Stair flip study · the main stair turned round: start and arrival at the NORTH end, next to the lift · Taif / Palm House V8.0 (work) · STUDY ONLY

ADOPTED 2 Nov 2026 (owner): option B, the freed landing as F-b, the balustrade, the store door onto the riwaq, the half-landing window, the entrance side light, the entry cupboard removed; applied to the design files. Owner's idea, 1 Nov 2026 · the same well (2.75 × 5.7 on axes, 2.525 × 5.50 clear), the same 22 risers × 0.164 / goings 0.28, flights 1.21 clear · nothing in the design files changes until the owner decides · all sizes assumed

1 · The two options on the ground floor

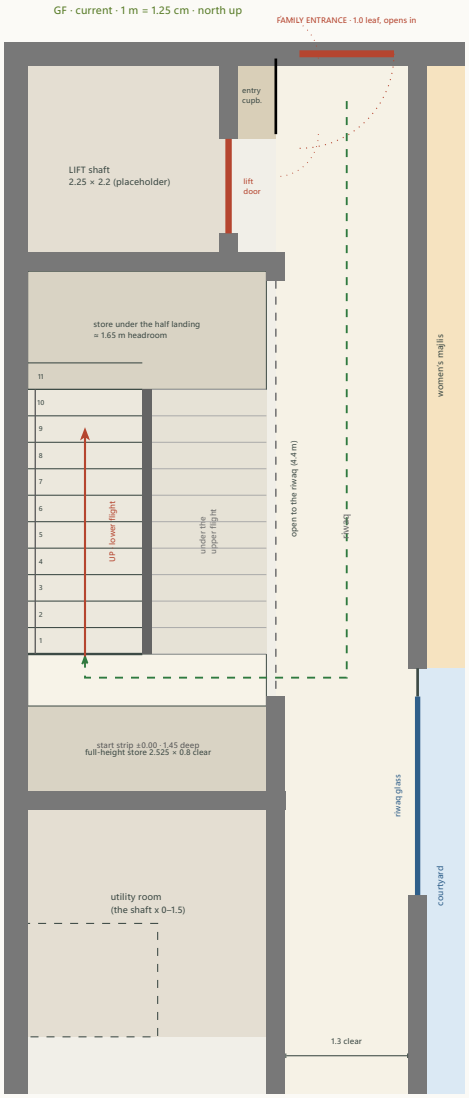
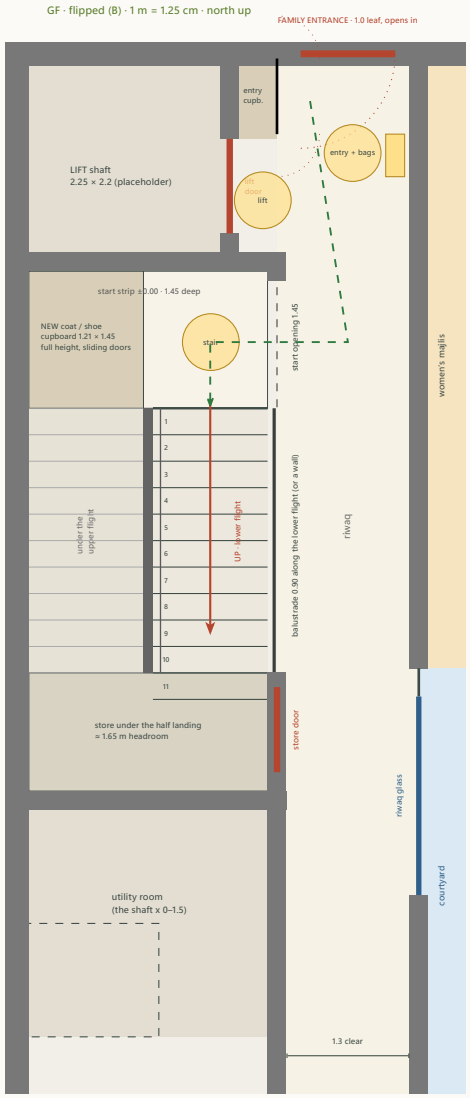
- **Current:** the lower flight on the **west** half starts at the **south** end (first riser y 6.35); the person comes along the riwaq, enters the well through its open east side (4.4 m open) and turns west onto the flight; in front of the first riser only **0.55 m** before the full-height store's wall (the start is really made from the side, under the upper flight's high end). Half landing at the north end (+1.80, a 1.65 m store below it, opening east onto the riwaq); the full-height store 2.525 × 0.8 clear at the south end.

- **Flipped (B, recommended of the two flips):** the lower flight on the **east** half starts at the **north** end (first riser y 3.75), **straight off the lobby**: a 1.45 m opening in the x 2.75 line between the lift notch and the flight, a start strip 1.45 m deep in front of the first riser. The lower flight rises along the riwaq side (a 0.90 balustrade on the riwaq, or a wall: the owner's choice); the half landing at the south end with its 1.65 m store (door onto the riwaq at y 6.7–7.6, in front of the courtyard glass; or into the utility room). The **west half of the start strip** (1.21 × 1.45, full height) becomes a **coat / shoe cupboard** beside the family entrance (sliding doors onto the strip).

- **Flipped (A):** the mirror image only (the lower flight stays west): the person crosses the whole strip to the far half before climbing; no cupboard. Not recommended; everything else below holds for both.

2 · Congestion test at the flipped start (drawn)

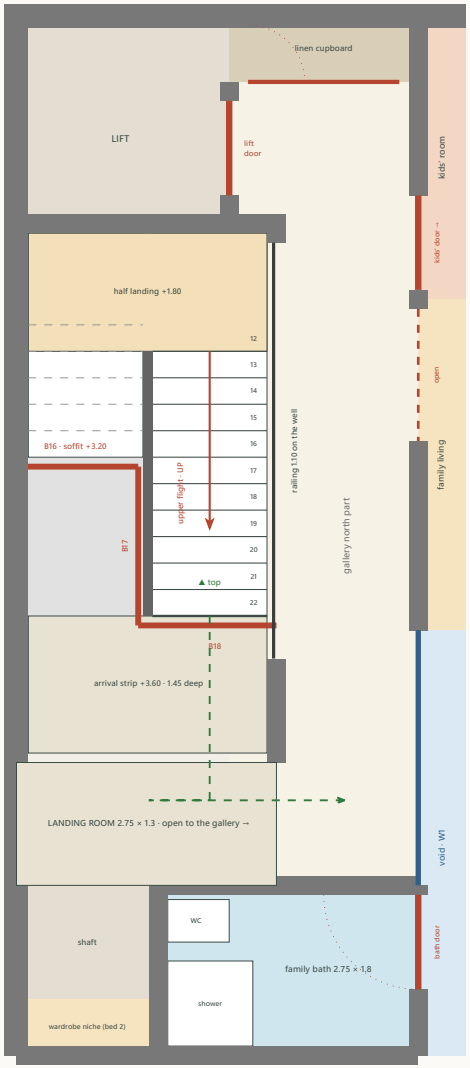
Three people at once: **one waiting for the lift** in the 0.50 m notch in front of its sliding door, **one coming in with bags** inside the family entrance's 1.0 m swing, **one starting up the stair** on the start strip, with the **entry cupboard's two 0.45 leaves open** into the lobby. Clear widths, not axes: the lobby **1.3 m** between the lift / cupboard wall face and the women's majlis wall face (the notch adds 0.5 m at y 0.9–2.2); the start opening **1.45 m**; the first riser **1.21 m** wide; the entrance **0.9 m** clear. The three stand in three separate zones along the lobby (y 0–1.0 the door swing, y 0.9–2.2 the lift notch, y 2.3–3.75 the start strip); the stair starter passes 0.3 m south of the lift waiter and never crosses the entrance swing: **OK**. Two people can pass in the 1.30 m lobby (0.60 + 0.60 + 0.10) but a person with two bags blocks it for a moment, as today. **Furniture up the stair:** the 90° turn from the 1.30 lobby through the 1.45 opening onto the 1.21 flight is a tight but normal house stair turn; the current start (0.55 m strip, sideways) is worse.

First floor · the arrival, the opening and its trimmers, the freed landing · current vs flipped

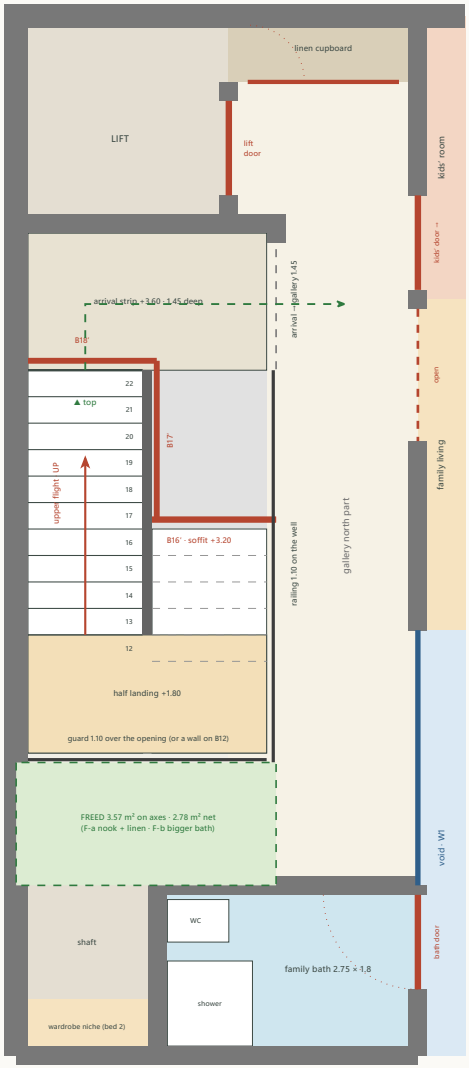
- **Current:** the upper flight (east half) lands at +3.60 on the arrival strip (y 6.35–7.8), then the **landing room** (2.75 × 1.3, y 7.9–9.2) and east into the gallery; the bedrooms and the family bath are at hand, the kids' room, the living and the lift are 6–9 m north along the gallery.

- **Flipped (B):** the upper flight (west half) lands on the arrival strip at the **north** end (y 2.3–3.75); the strip opens east onto the gallery's north part (1.45 m), **0.10 m south of the lift notch**: the lift's first-floor door, the linen cupboard (its leaves swing south, 0.6 m), the kids' room door (opens into the room) and the family living's opening are all within 1–3 m. The gallery's north part (1.30 clear) carries the arrival traffic as it carries the lift's today; the linen leaves and the lift door are 1.0 m north of the arrival: no clash. The railing on the well runs from the arrival (y 3.75) to the south wall; the landing room is **freed** (§ 5).

FF · flipped (B) · 1 m = 1.25 cm · white = opening · grey = slab

4 · The first-floor opening and its trimmers

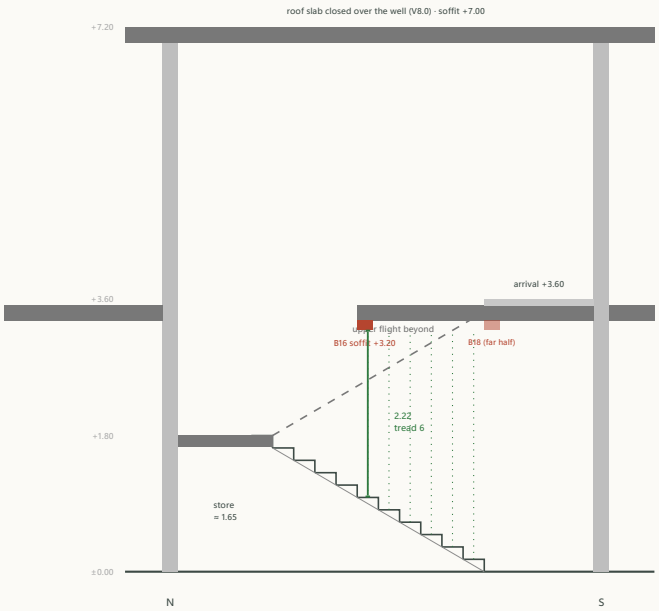
- **Current (studies/structure.typ):** an L-shaped opening ≈ 8.2 m²: the west half open from the north wall to B16 (y 4.85), the east half open to B18 (y 6.45); B16 (0.20 × 0.40, soffit +3.20) from the west wall to B17; B17 (x 1.29, on the lower flight's side of the split) from B16 to B18; B18 (y 6.45) from B17 to the riwaq-line beam B10 (x 2.75).

- **Flipped (B):** the **same opening turned round** (≈ 8.2 m²): the east half open from B16′ (y 5.33) to the south wall, the west half from B18′ (y 3.65) to the south wall. **B16′** (y 5.33) from the riwaq-line beam B10 to B17′; **B17′** (x 1.49, on the east, lower flight's side of the split: never over the upper flight) from B16′ to B18′; **B18′** (y 3.65, the arrival edge) from the west wall to B17′. The same zigzag, mirrored: one beam-on-beam junction at each end of B17′, the torsion the engineer's; B18′ now bears on the west wall (as B16 does today) and B16′ on B10 (as B18 does today). **Neither better nor worse** for the structure: the spans (1.3–1.6 m) and the bearings are the same kind. **Not verified.**

- **Slab edges:** the arrival strip (1.45 × 2.525) spans between the north wall beam B11 (y 2.2) and B18′; over the lower flight's first six treads the slab spans from B18′ to B16′ (1.6 m) between B10 and B17′. The guard round the opening: the railing on x 2.75 from the arrival south to y 7.9, the well's south wall line y 7.9 (a 1.10 guard or a wall on B12), the upper flight's balustrade on the split.

Headroom · a section along the lower flight for each option · the slab 0.2 thick (soffit +3.32), the trimmers 0.20 × 0.4 (soffit +3.20), the finish 0.08 · over the full walking width of every tread

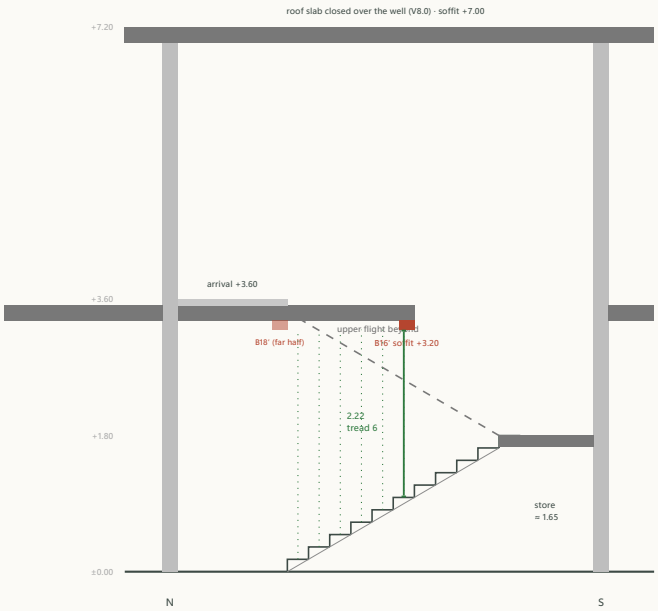
current · section along the lower flight, looking east · 1 m = 1 cm

flipped (B) · section along the lower flight, looking east · 1 m = 1 cm

The upper flight, the half landing and the arrival are under the open well (the roof slab's soffit +7.00): ≥ 3.4 m. Minimum of this option: **2.22 m** at tread 6 under the trimmer, across the whole 1.21 m width (the trimmer spans the half); B17 over the inner 0.10 strip of treads 1–5: ≥ 2.38 m.

The upper flight, the half landing and the arrival are under the open well (the roof slab's soffit +7.00): ≥ 3.4 m. Minimum of this option: **2.22 m** at tread 6 under the trimmer, across the whole 1.21 m width (the trimmer spans the half); B17′ over the inner 0.10 strip of treads 1–5: ≥ 2.38 m.

Verdict on the headroom: identical in both options (**2.22 m** at tread 6 under the trimmer, 2.83 m at tread 3 under the slab; ≥ 2.10 required, the 2.20 aim just met) because the flip mirrors the geometry: the trimmers sit in the same places relative to the treads. **The flip neither improves nor worsens the trimmers.** What would improve both: trimmers 0.20 × **0.30** (soffit +3.30 → **2.32 m** at tread 6) if the engineer accepts a 0.30 depth for the 1.3–1.6 m spans, or the slab edge moved one tread (the opening 0.28 m longer, ≈ 0.35 m² more void, tread 6 under open sky → the minimum moves to tread 5: 2.38 m). Both options can take either. The walls' handrails run the full flights (0.08 off the walls); the central handrail on the 0.10 split.
